VIRGINIA  
SHIPBUILDING CARRIER AND  
INTEGRATION CENTER  
ADVANCED

ALYSON LARIMER  
LIGHTING/ELECTRICAL  
AE FACULTY CONSULTANT  
DR. RICK MISTRICK  
DECEMBER 10, 2010

Figure 1: Floor plan and photo of Lobby/Atrium Space

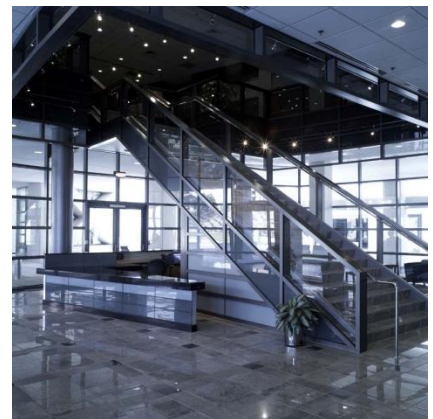
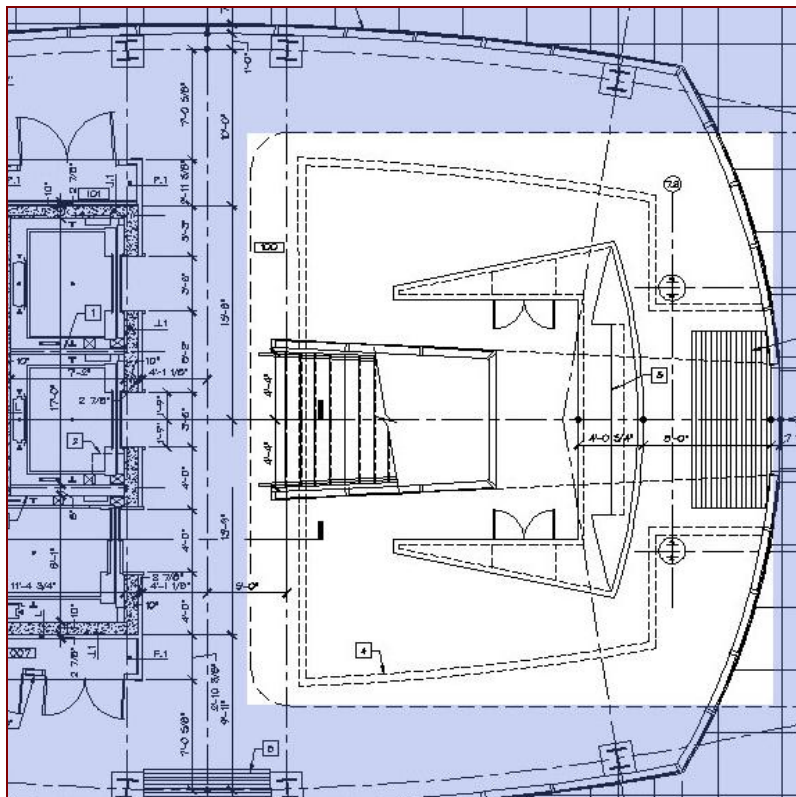
### Lobby/Atrium

- Daylighting should be looking at to see how much electric light is needed for the rest of the space.
- Contrast ratios within space were lost.
- Accessibility.

### Lobby/Atrium

- May be too many layers of light, will only need one source to illuminate stairs.

#### Lobby/Atrium

- Strongest space.
- Glowing front reception desk was good.
- Stairs were illuminated well.

Figure 2: Second through sixth floor open office floor plan

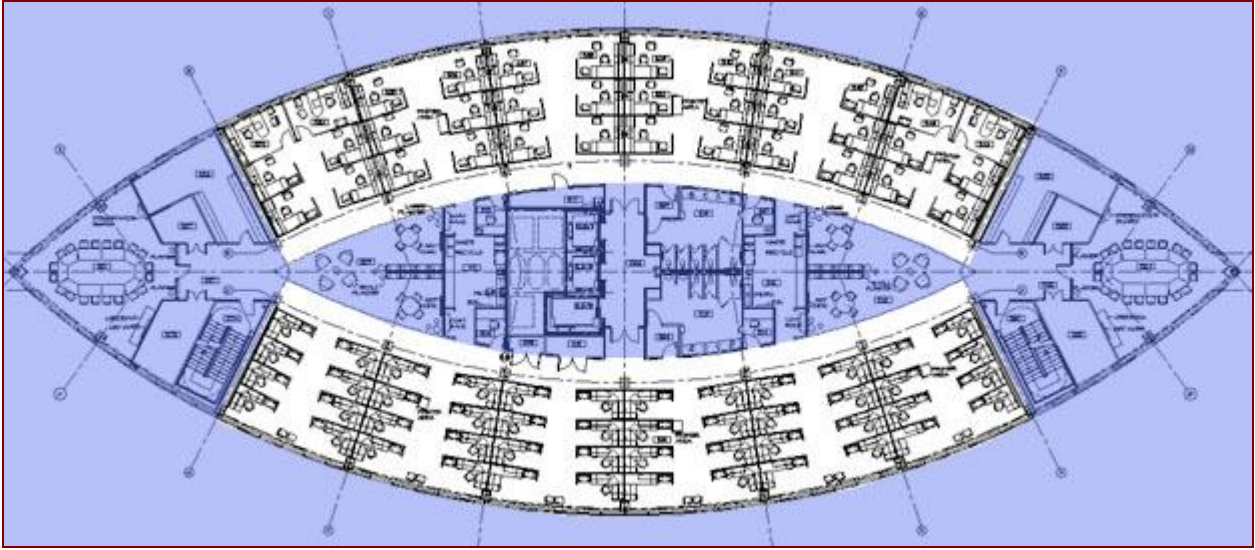
- How does clear and fritted glass affect building appearance from exterior?

### Open Office Space

- Play architect, redesign workstations to avoid using partitions so occupants can enjoy the beautiful exterior glazing the building was designed for.
- Check energy code, probably will not need the addition lighting for vertical highlights in office area.
- Different pendant sizes may be distracting, think about using a pendant that mimics the shape of the building rather than a round shape.

- Perspective showed space but was not a large enough viewport, what happens at joining of walls and furniture layouts within space.

Figure 3: Auditorium floor plan

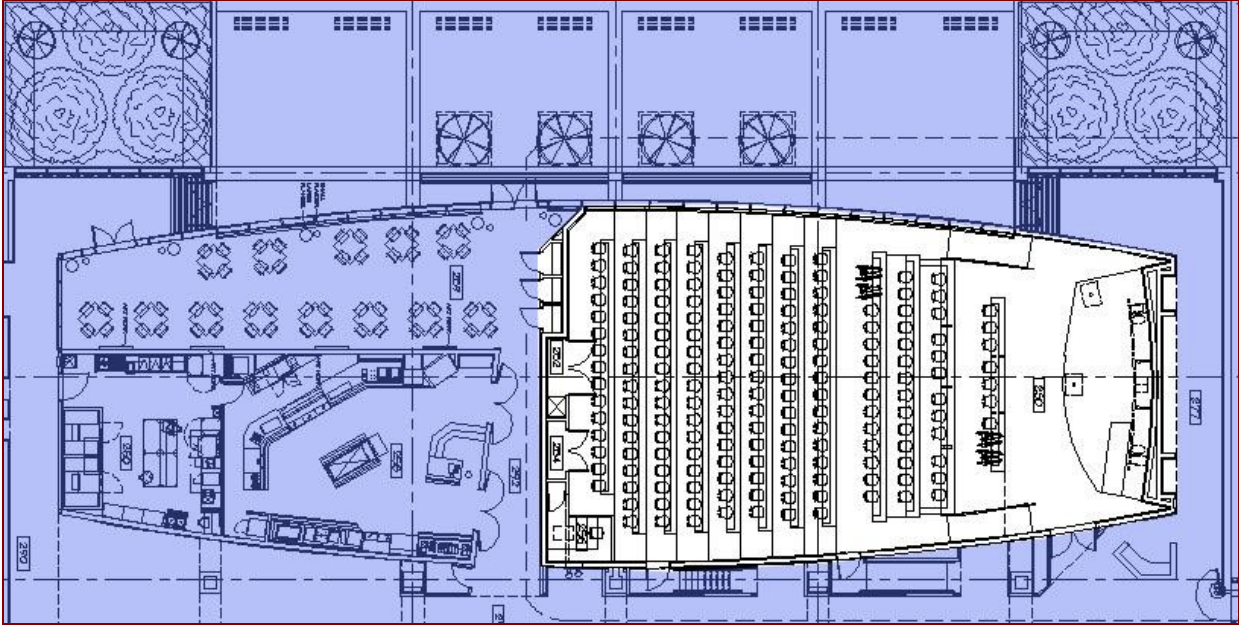
### Multi-Purpose Space

- Daylighting integration study should be done to see impact during occupancy hours of 8am to 5pm.
- “Pools of Light” was a cool idea.
- Interactive stair feature was cool but a bit over the top.

### Multi-Purpose Space

- Incorporate shading systems for control of daylight.
- Second and third schematic both employ wall washing, whereas the first schematic adds general lighting utilizing downlights which could potentially be very shadowy.
- Second schematic needs to show more defined ceiling wash.
- Third schematic with glowing ceiling may be enough illumination for task lighting and would not need pendants.
- Change color of ceiling from blue to white during presentation time to avoid unwanted color rendering appearances.

#### Multi-Purpose Space

- Schematic three was strongest and provides more options.
- Other schematics created too much uniformity and lost concept within space.
- Define problems within space and how you propose to solve them.

Figure 4: Exterior gathering space proposed design site

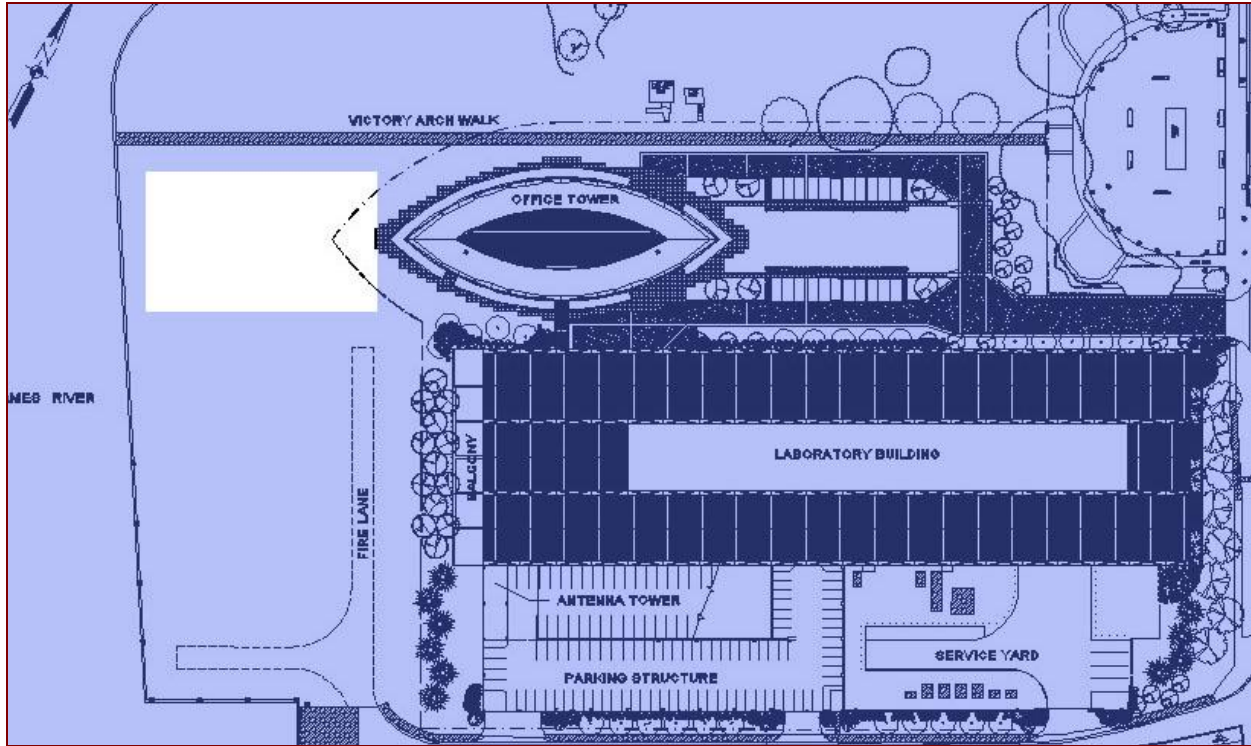
### Exterior Gathering Space

- “Killer idea”.
- Strong link between concept and design: water.
- Think about lighting for vertical rendering (faces).
- Too many layers of light within design, make points of interest by having areas of higher and lower illuminances.
- Interactive fountains were confined. Perhaps break the rigid flow and add freedom to the fountains by creating an interactive water feature.

### Exterior Gathering Space

- Make sure to emphasize “public” space in presentation.
- Too many layers of light.
- Arch lighting may need more uplighting to appear more even at middle cornice.
